UNITED STATES NUCLEAR REGULATORY COMMISSION REGION II 101 MARIETTA STREET, N.W. ATLANTA, GEORGIA 30323

Report Nos.: 50-327/88-60, 50-328/88-60

Facility Name: Sequoyah Units 1 and 2

## Summary

ATTACHMENT

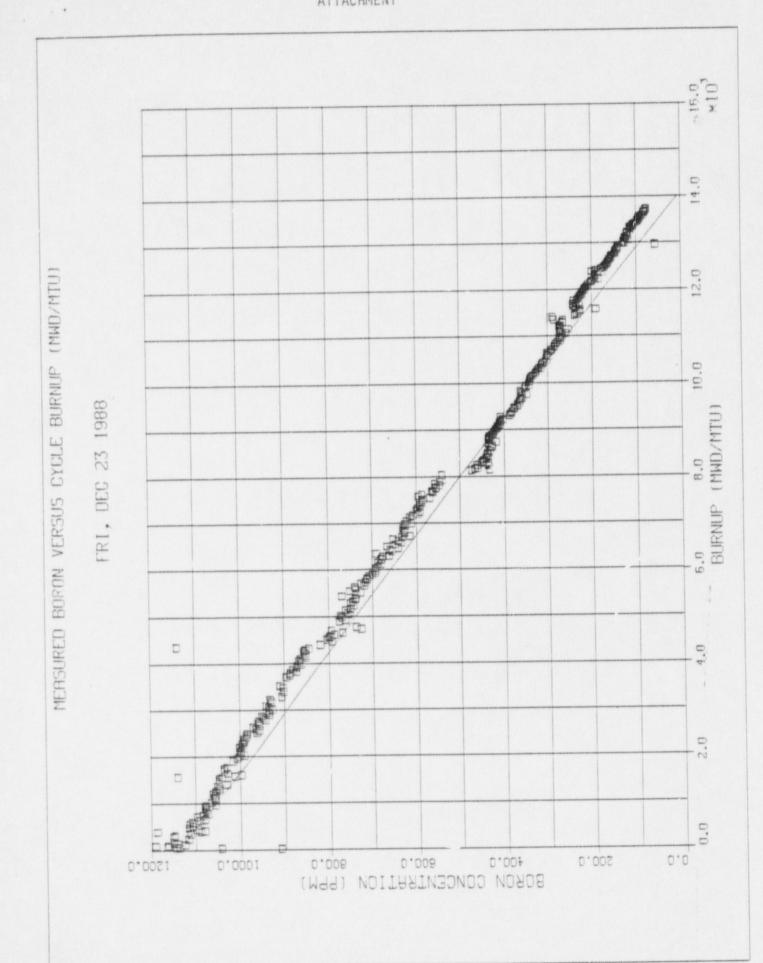
Similarly, no significant modeling errors were apparent in the HFP critical boron concentration data for Unit 2 operation (attached). The inspector discussed with the licensee how the measured and predicted curves were derived, and what factors were included. The agreement between the measured and predicted data was acceptable, and the observed effects of the extended shutdown on the agreement between measured and predicted boron concentrations were consistent with industry experience.
